# **FINAL DRAINAGE PLAN**

## **THE RIDGE AT LORSON RANCH**

**FILING NO. 1: SF 22-004**

**JANUARY, 2022**  
**REV. MARCH, 2022**

SHEET NUMBER **C9.6**  
TOTAL SHEETS: 23

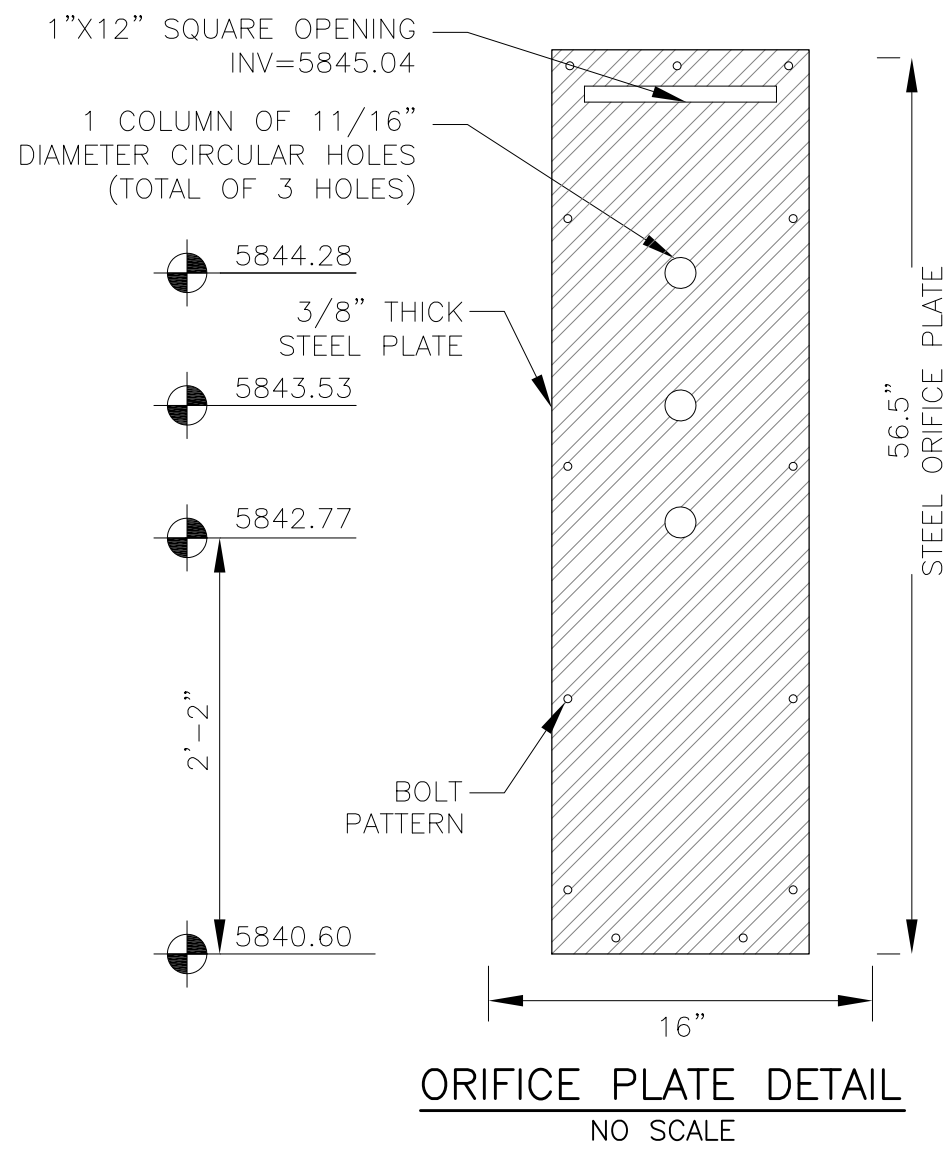
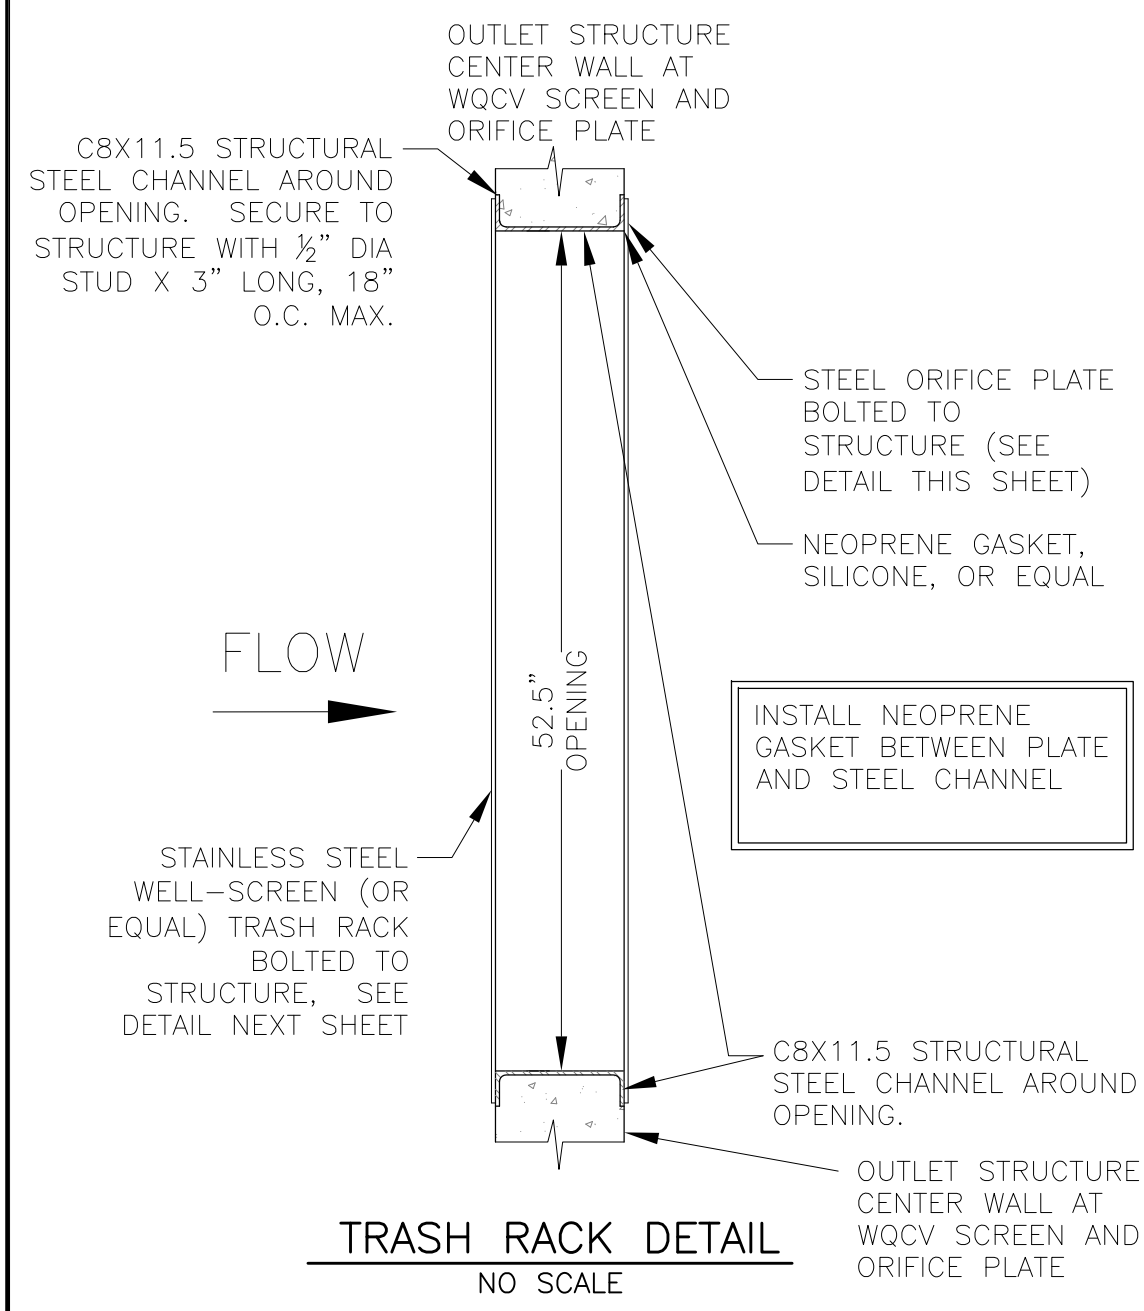
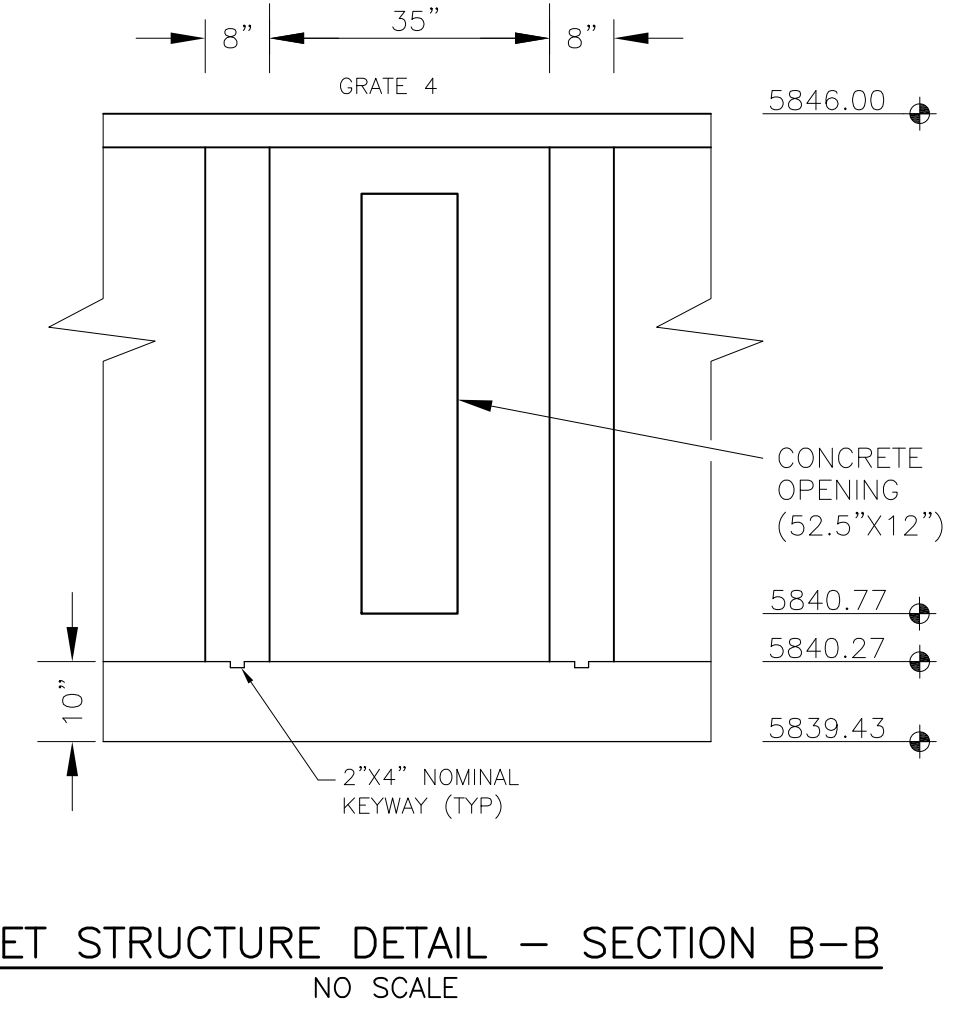
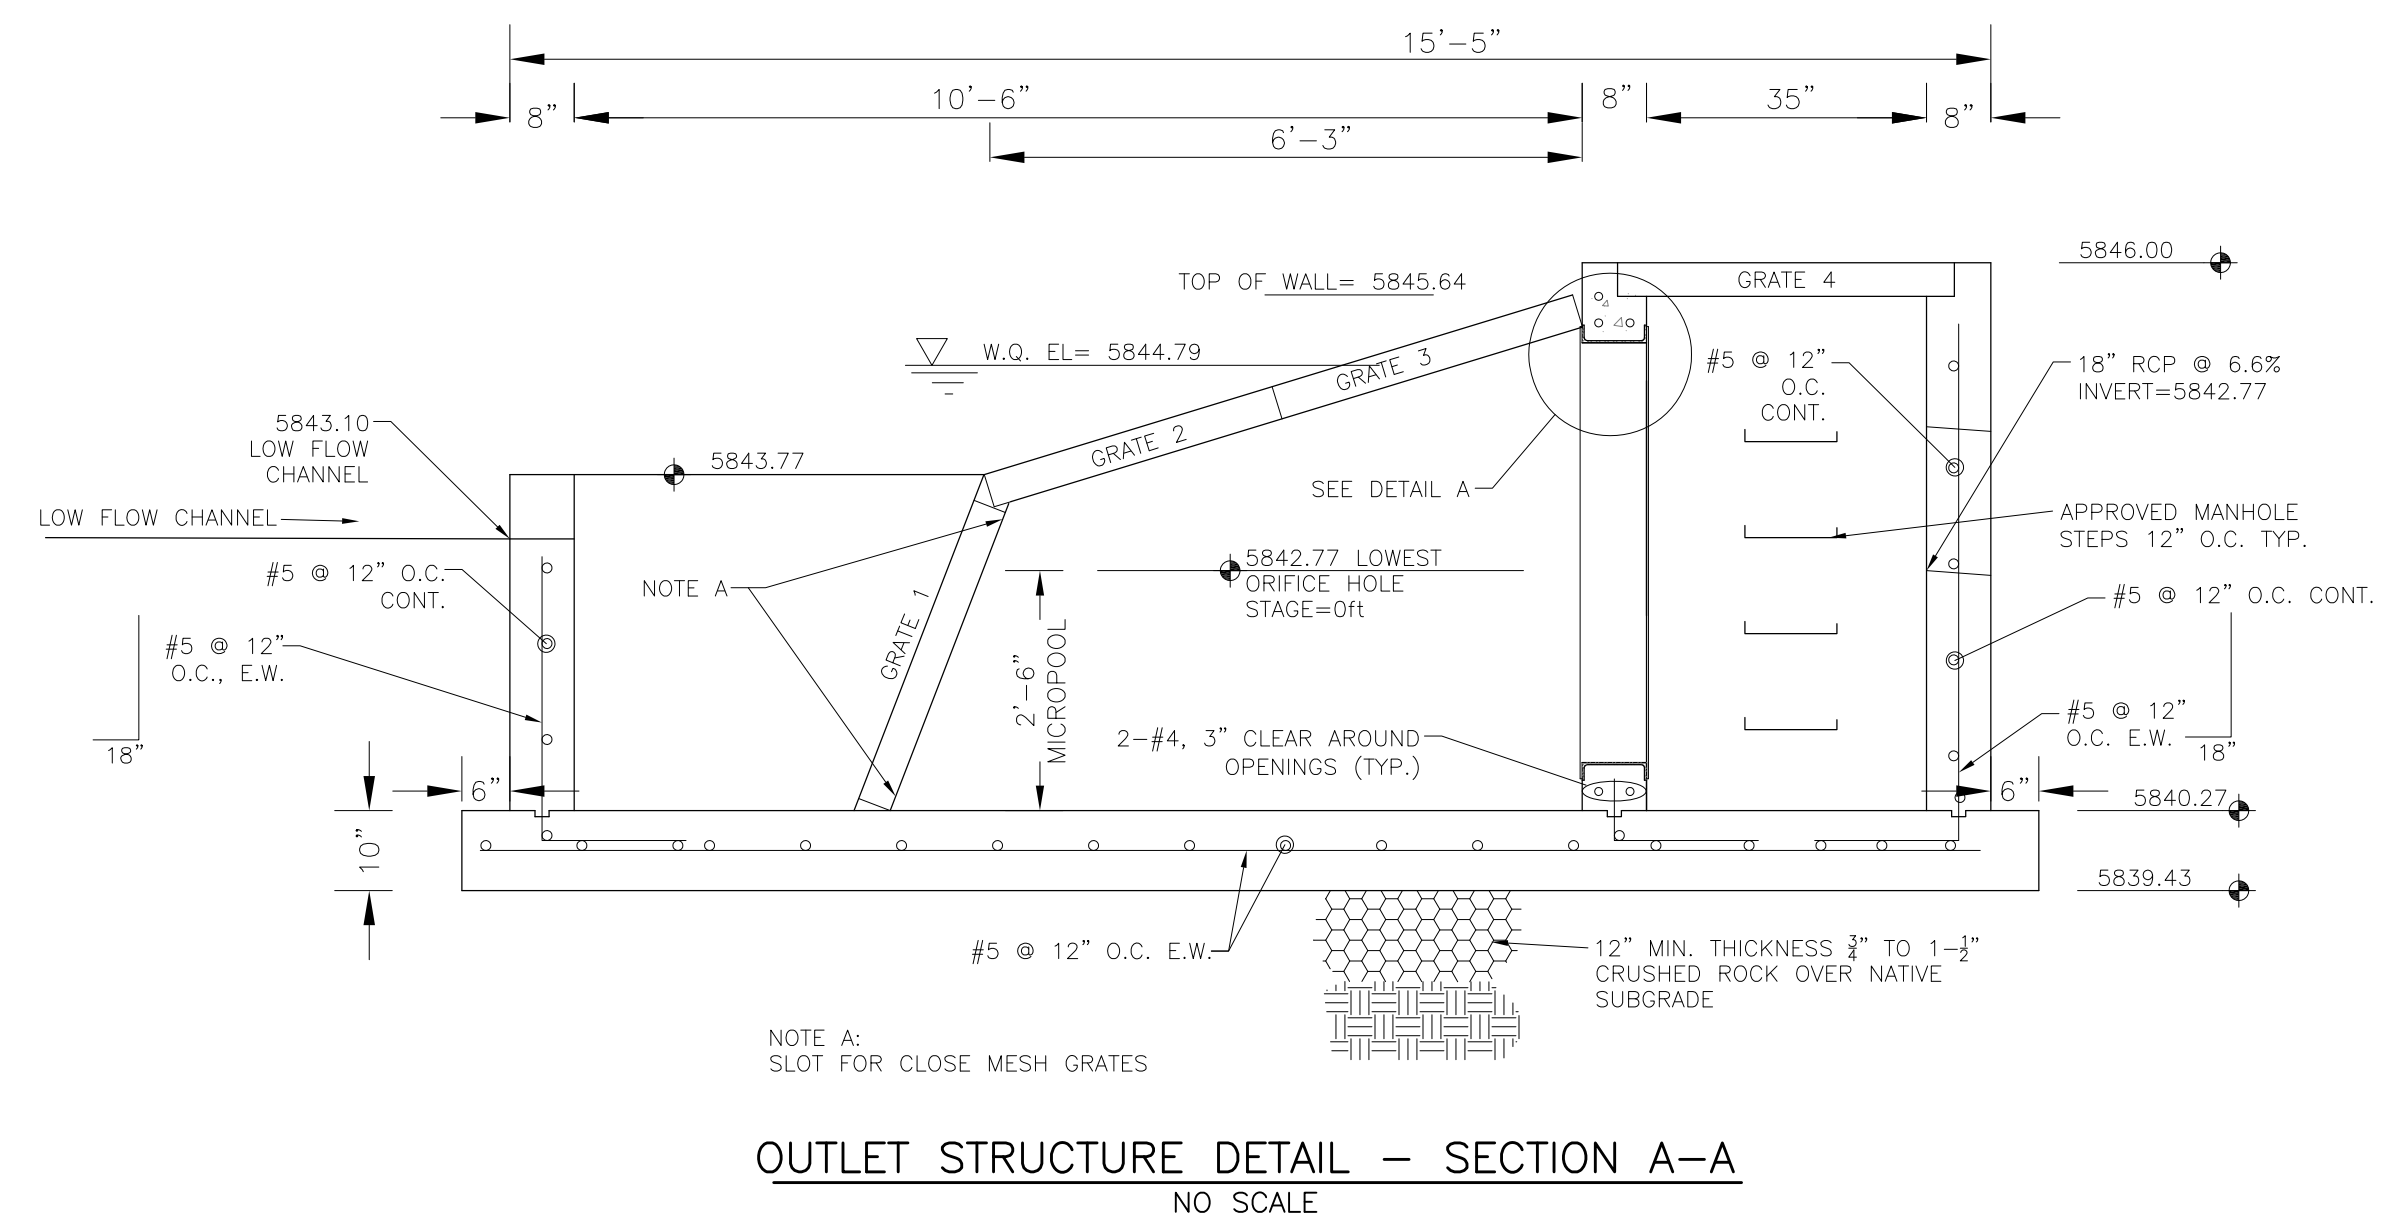
Unresolved: should be 36" per pg 199 above.

Unresolved: should be 72" per pg 199 above.

Review #2 update:  
Revise outlet structure accordingly or revise MTFD calcs on pg 204 to reflect this outlet configuration so there is not a discrepancy.

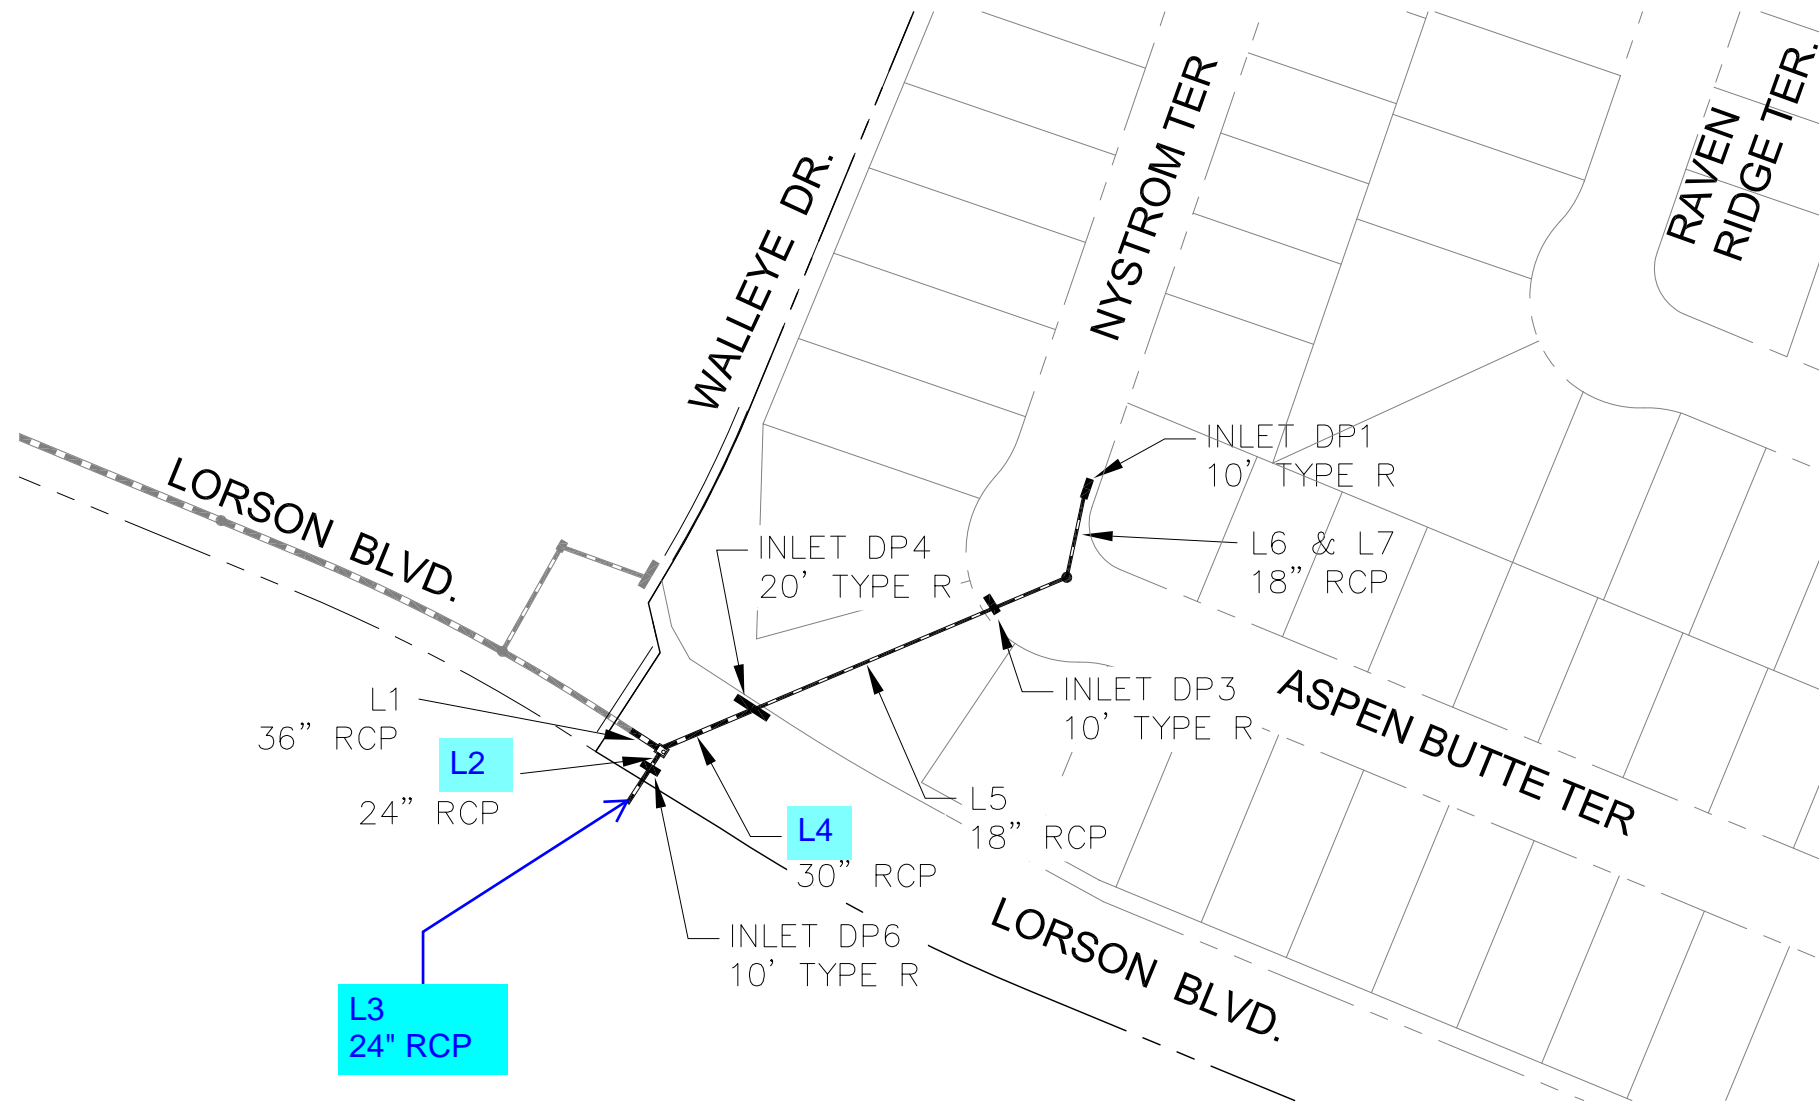
Update storm sewer calculations as flows at proposed inlets may have changed
